SAFETY ADVISORY # 15-242 Voltage Exterior Folding Ladder

Parts Required per Unit: KRV # 373484 Rivet - 3/16" Rivet (Fig. 1)

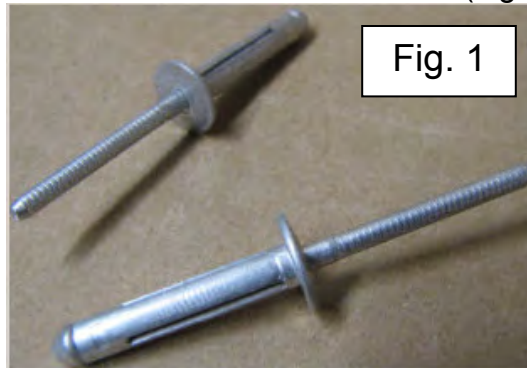
Keystone is conducting a voluntary **RECALL** notification campaign in accordance with the National Highway Transportation and Safety Act. It has been decided the vehicles in this recall population may have been manufactured with the exterior folding ladder not properly secured to the sidewall of the vehicle. If the ladder is not fastened securely to the sidewall, it may pull loose from the vehicle while an individual is utilizing the ladder, leading to an increased risk of personal injury.

- Step 1** Remove 4 screws from each of the upper four mounting plates that are mounted to the sidewall (not the ones in the lower skirt metal), one plate at a time.
- Step 2** To determine substrate material at each mounting location, use a 5/64" drill bit drilling in approximately 1" max. deep into sidewall at each location where screws were removed from.
- Step 3** Carefully observe whether wood, foam, metal or nothing is removed by the drilling process.
- If wood is removed, use screwdriver to reinstall the screw.
 - If foam, metal or nothing is removed, drill with 13/64" drill bit and install one of the 373484 rivets (Fig. 1).
- Step 4** Repeat process until all 4 upper mounting plates have been secured / completed.
